Docket Number:	17-BSTD-01
Project Title:	2019 Building Energy Efficiency Standards PreRulemaking
TN #:	221582
Document Title:	SEIA & CALSEIA Comments on Pre-Rulemaking 2019 BEES, Part 6, Oct. 4-5 Workshop
Description:	N/A
Filer:	System
Organization:	Joseph H. Cain, P.E.
Submitter Role:	Public
Submission Date:	10/20/2017 4:59:07 PM
Docketed Date:	10/20/2017

**SEIA & CALSEIA Comments on Pre-Rulemaking 2019 BEES, Part 6, Oct. 4-5
Workshop**

Re: Docket 17-BSTD-01 2019 Building Energy Efficiency Standards Pre-Rulemaking: 2019 Residential Standards: Residential Solar Photovoltaic, Storage, Energy Design Rating and Grid Impacts;

Figure JA12-2: Example of Points Where Measurement Shall Be Made Using a Solar Assessment Tool

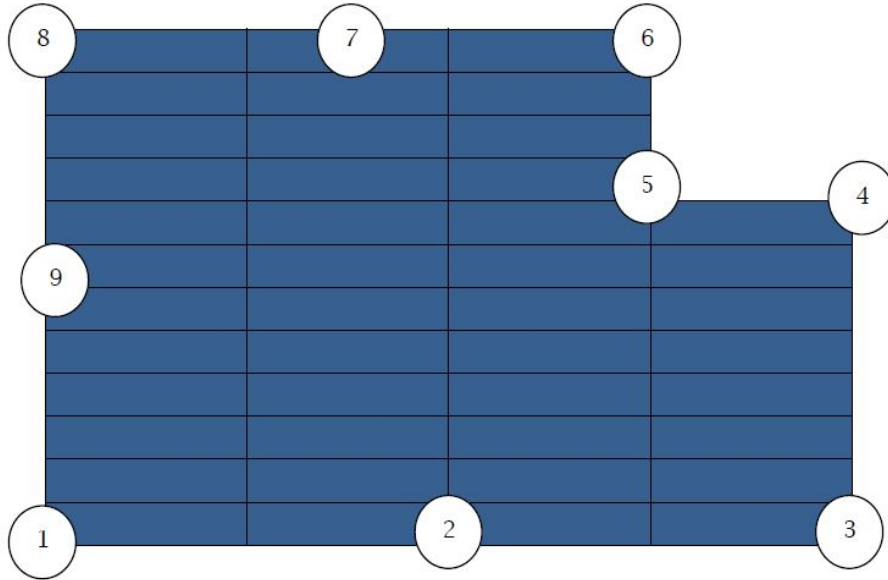
We believe Solar Assessment Tool Measurements are inappropriate for new home construction. Computer modeling based on project plans is the fundamental tool for system design. It is overly restrictive to assume there is a stopping point in construction where someone would go on the roof to take measurements. We do not see indication of when this inspection point would be carried out – i.e., after sheathing installation but before frame inspection when the roof is stacked – and how that would affect the overall inspection process. We also request more information on how the data will be used if at all. We recommend a complete strike-out of Solar Assessment Tool Measurements from JA12. If not a complete strike-out, we believe it should be optional (but likely not used).
